CITY OF LA VISTA
MAYOR AND CITY COUNCIL REPORT
NOVEMBER 5, 2019 AGENDA

Subject:	Type:	Submitted By:
APPLICATION FOR PUD SITE PLAN – STRECK, INC, LOTS 1 & 16, HARRISON HILLS (S 118 TH ST & EMILINE ST)	◆ RESOLUTION ◆ ORDINANCE RECEIVE/FILE	CHRISTOPHER SOLBERG SENIOR PLANNER

RE: Planned Unit Development – Initial Review
Streck, Inc. – Harrison Hills

RE: Planned Unit Development – 2nd Review
Streck, Inc. – Harrison Hills

PLANNED UNIT DEVELOPMENT
PHASING PLAN EXHIBIT

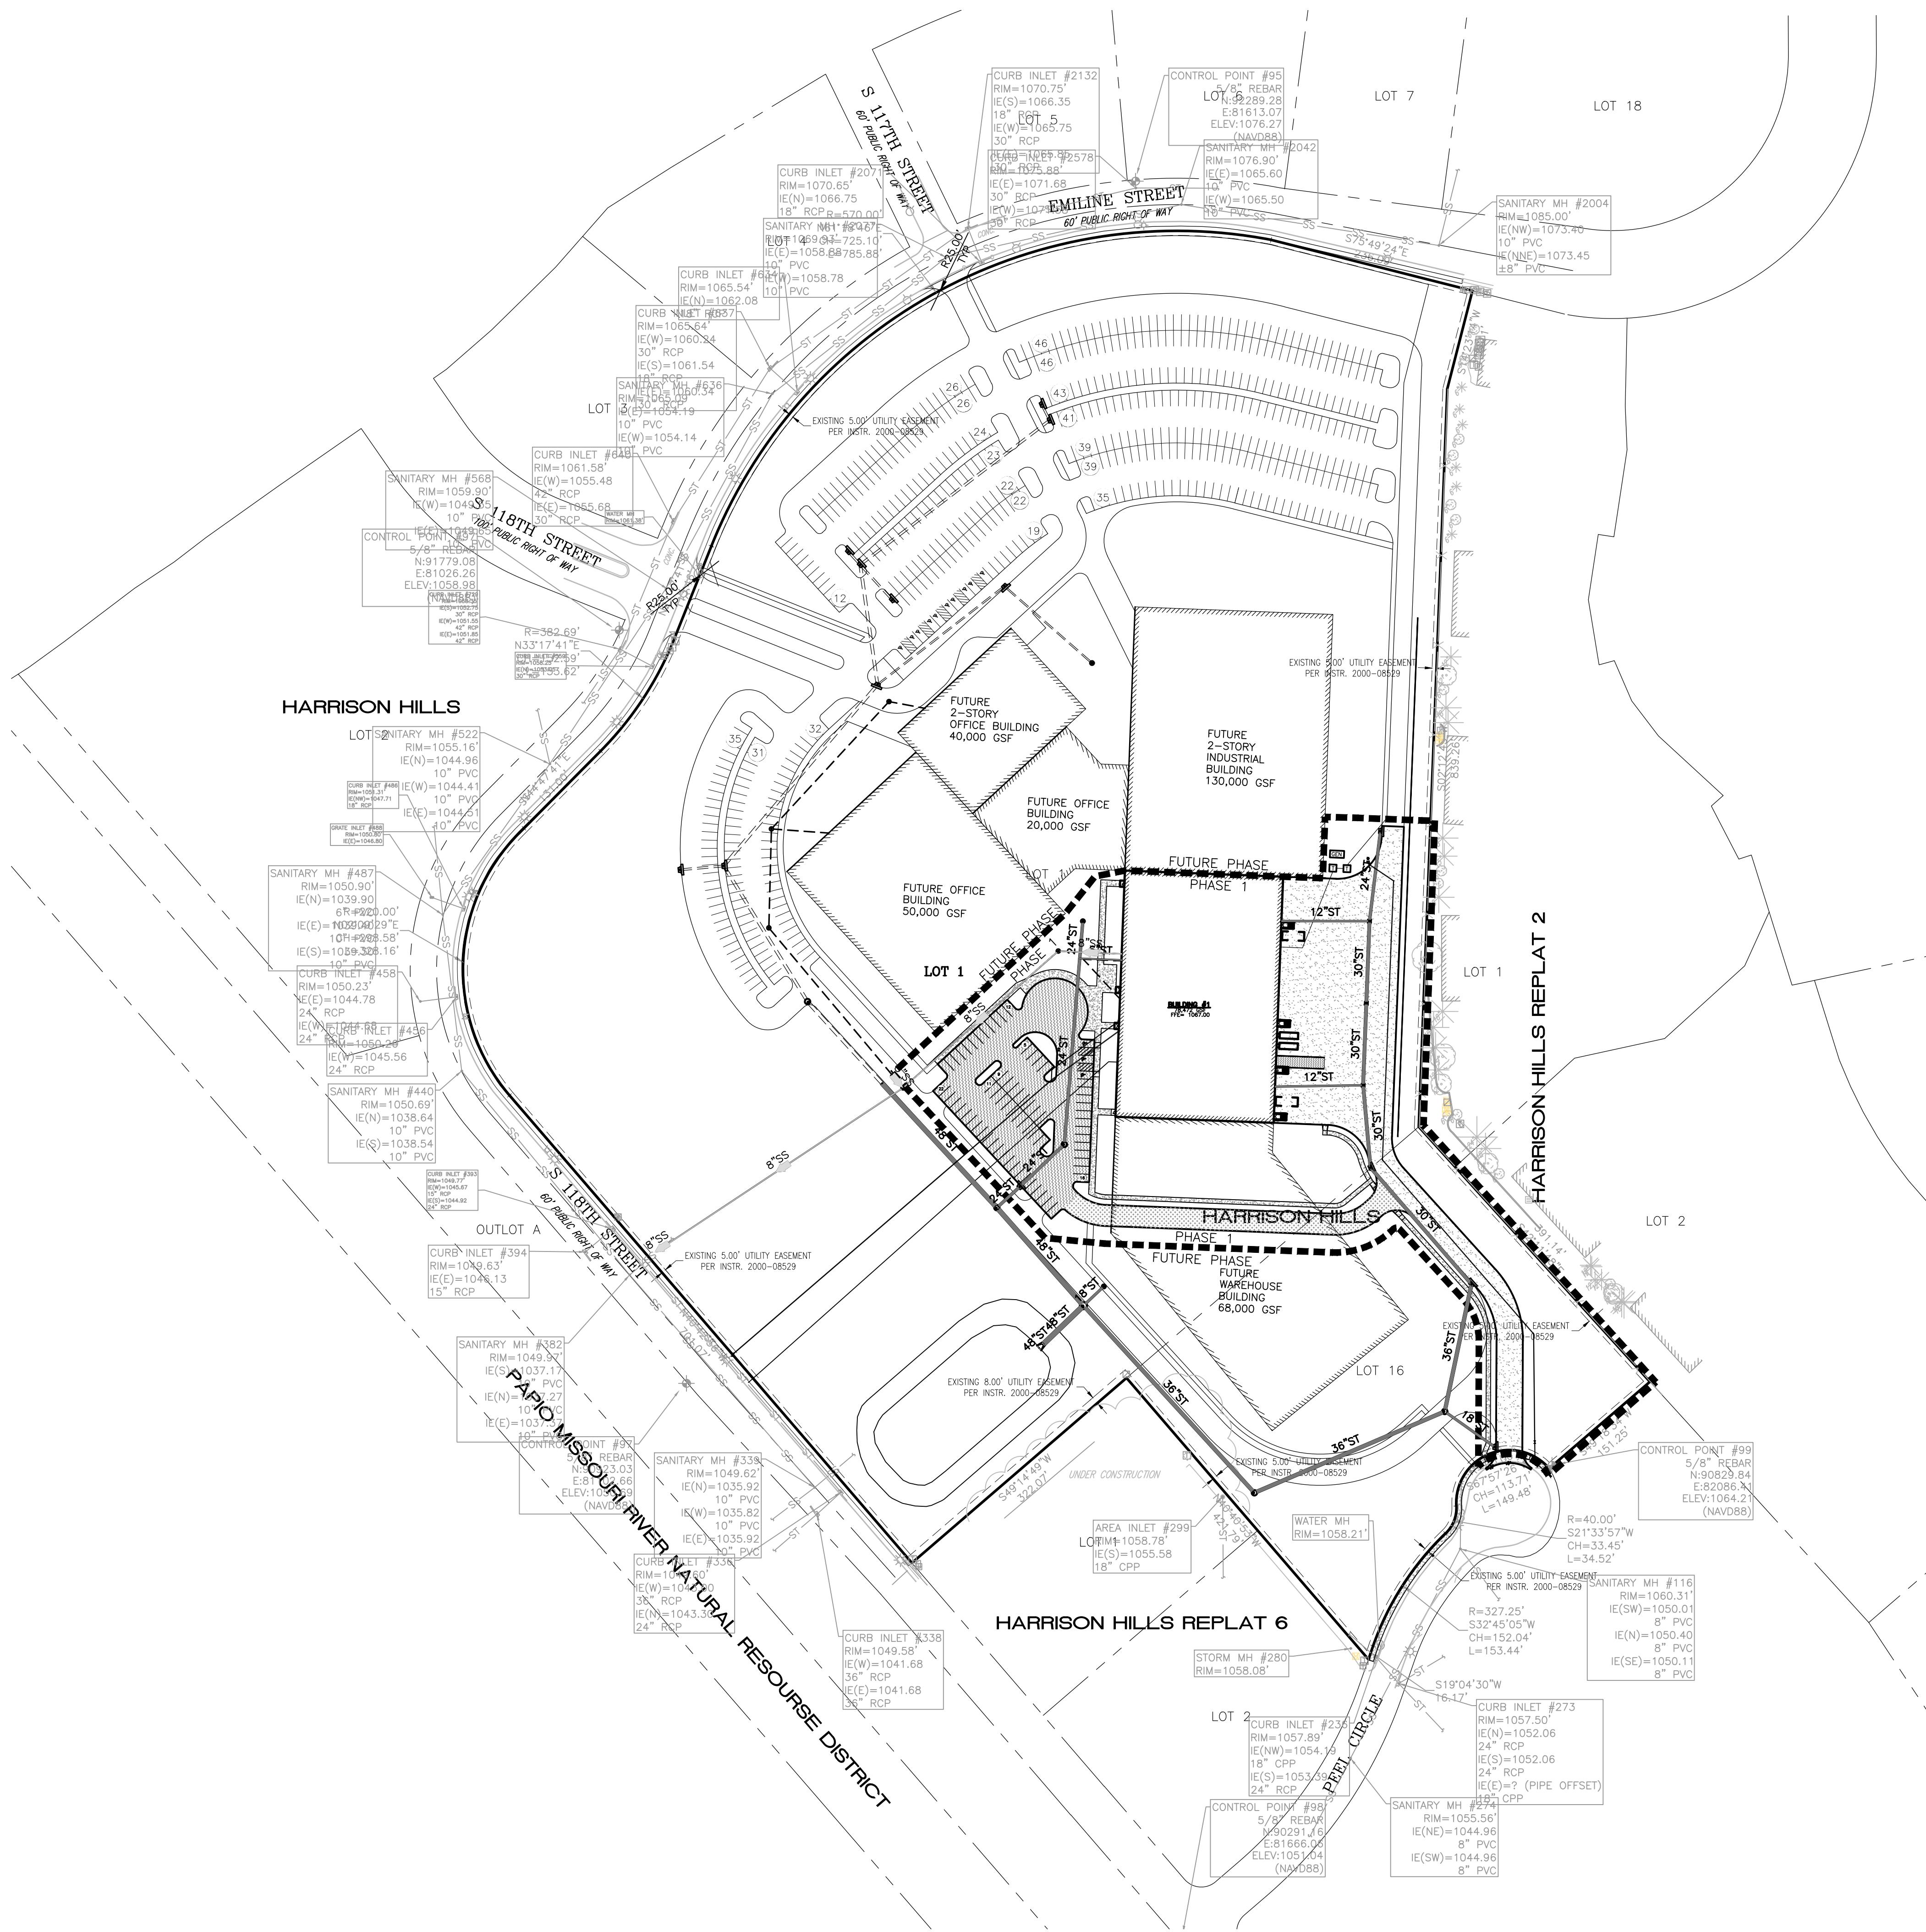
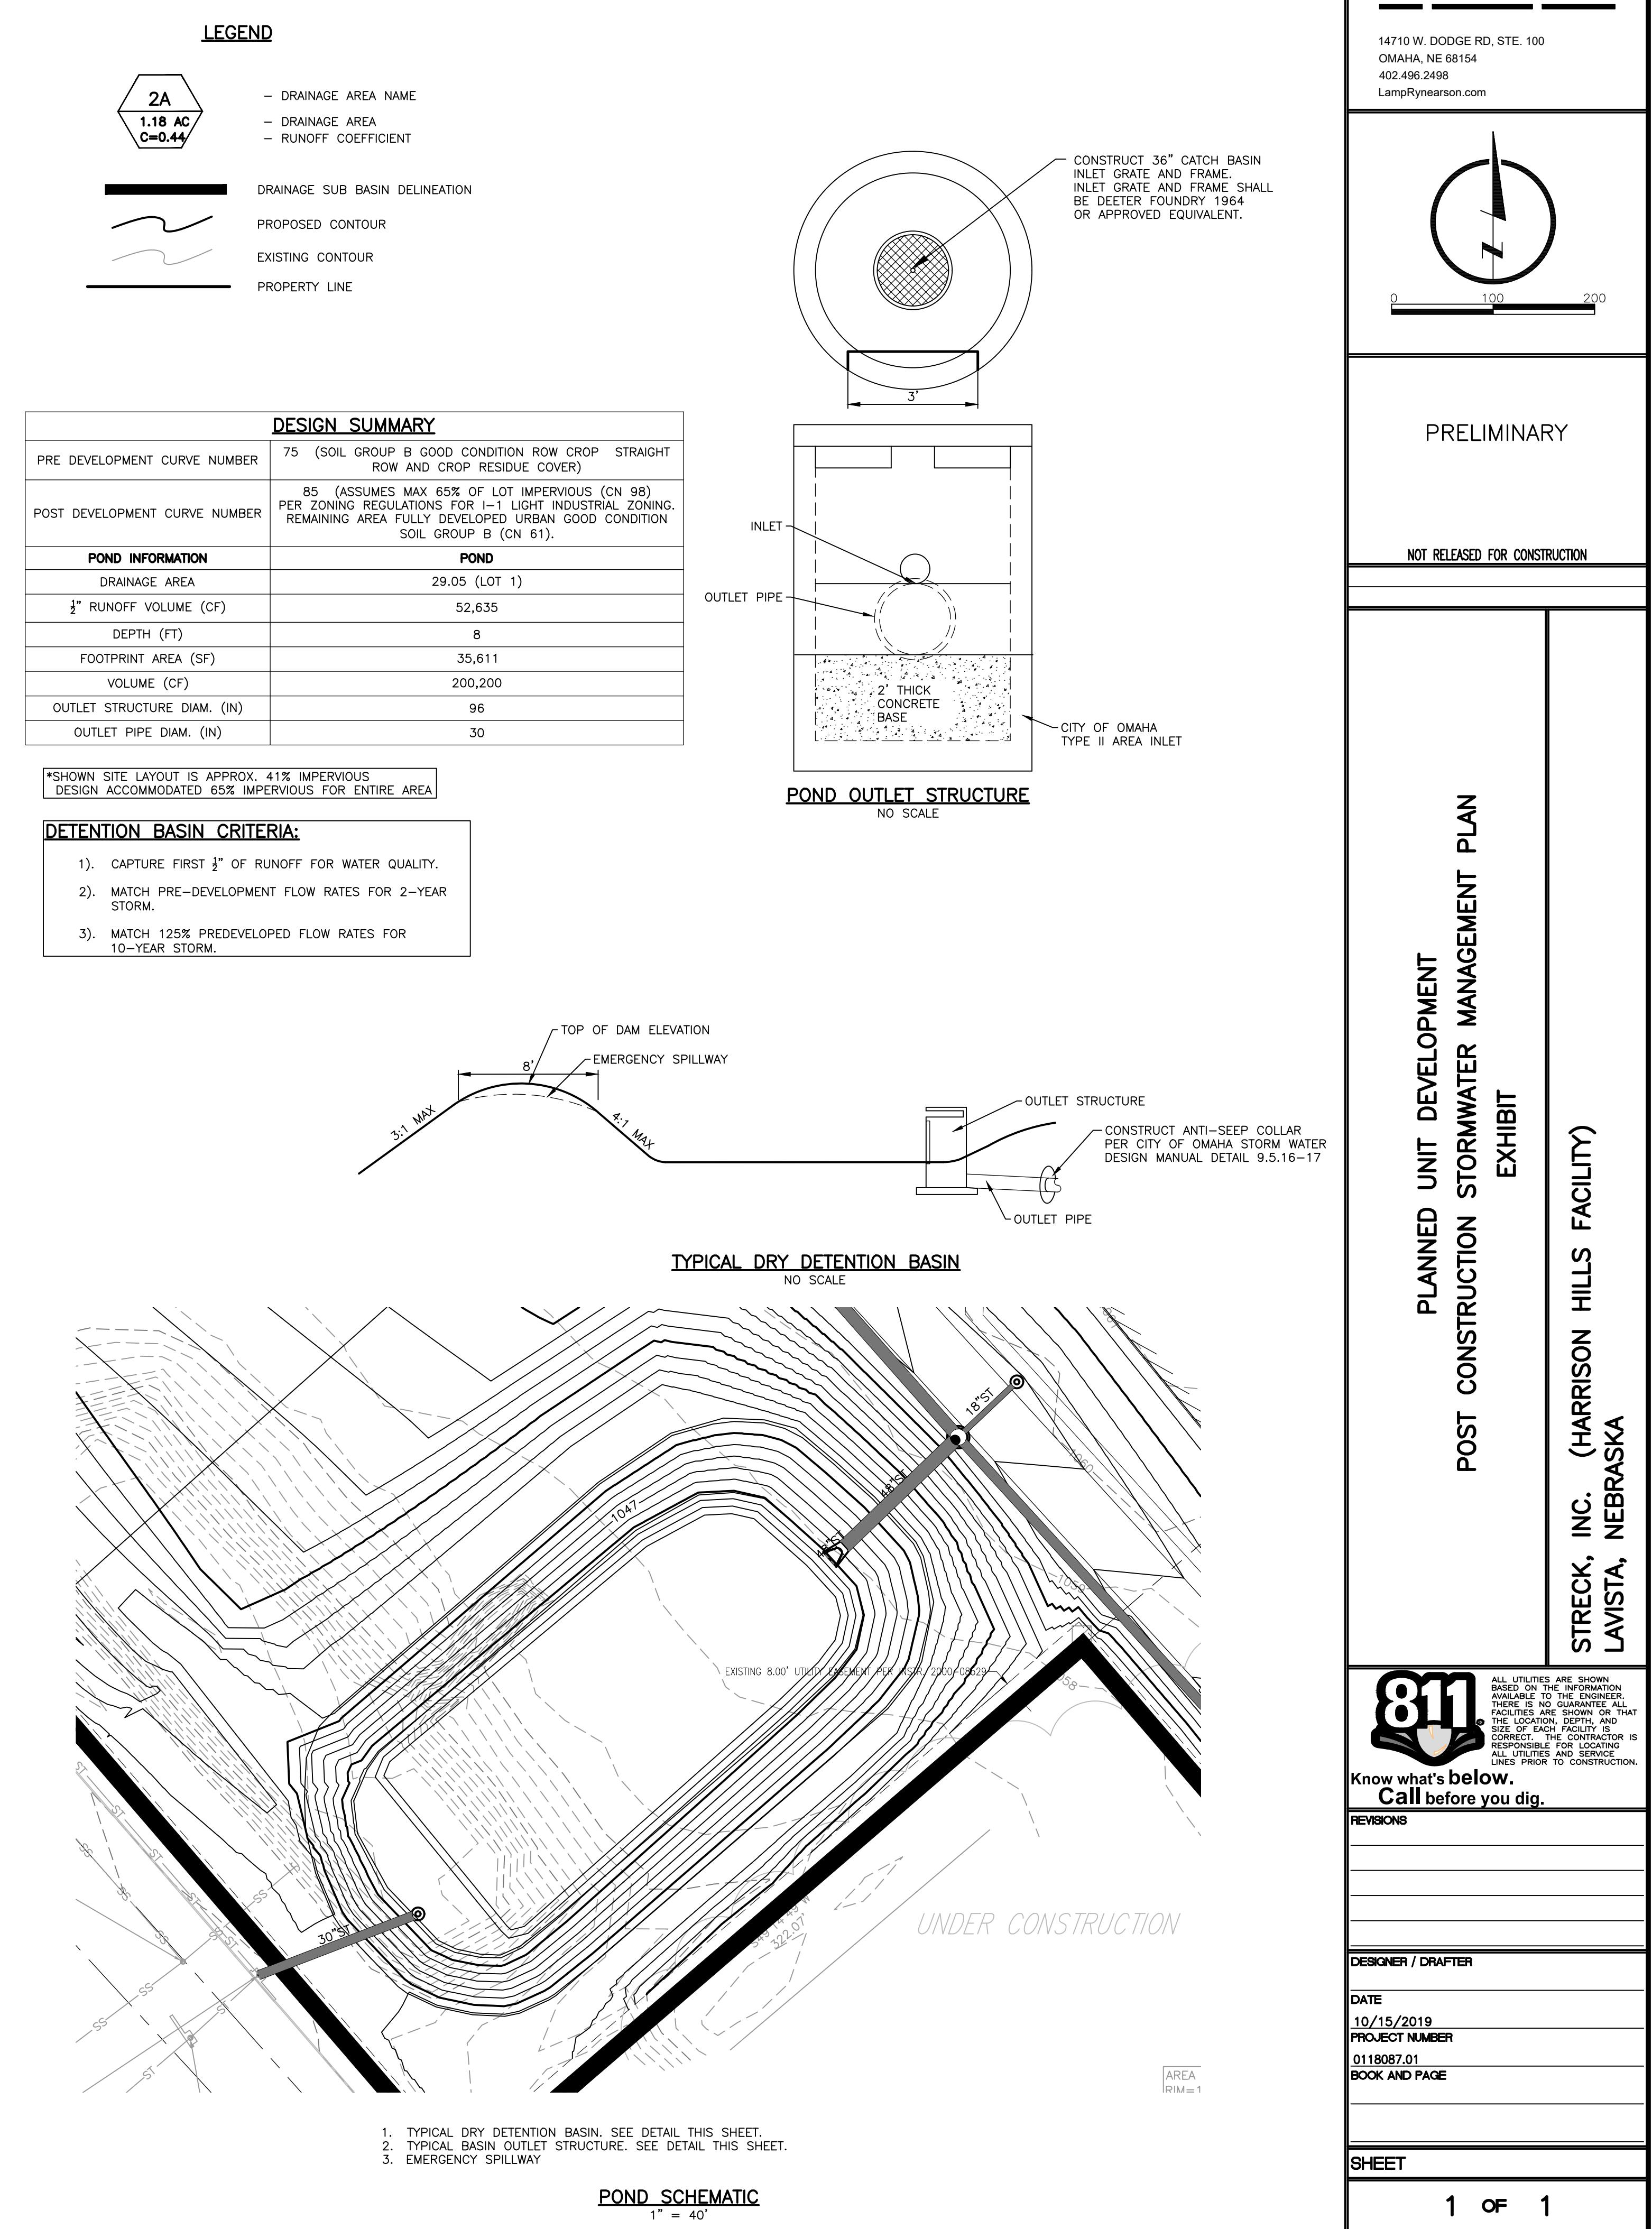
6. Comment Response #11 – Sanitary sewer connection fees and stormwater management fees were noted per the PUD Development Fee Table per the PUD Phasing Plan Exhibit, however the fee rates were not consistent with the current Master Fee Ordinance. Current Watershed Fees are \$4,963/acre (as of 7/1/19) and Sewer Connection Fees are \$7,407/platted acre (as of 1/1/2019).

Response: The PUD Development Fee Table has been updated per the 2019 fees listed above.
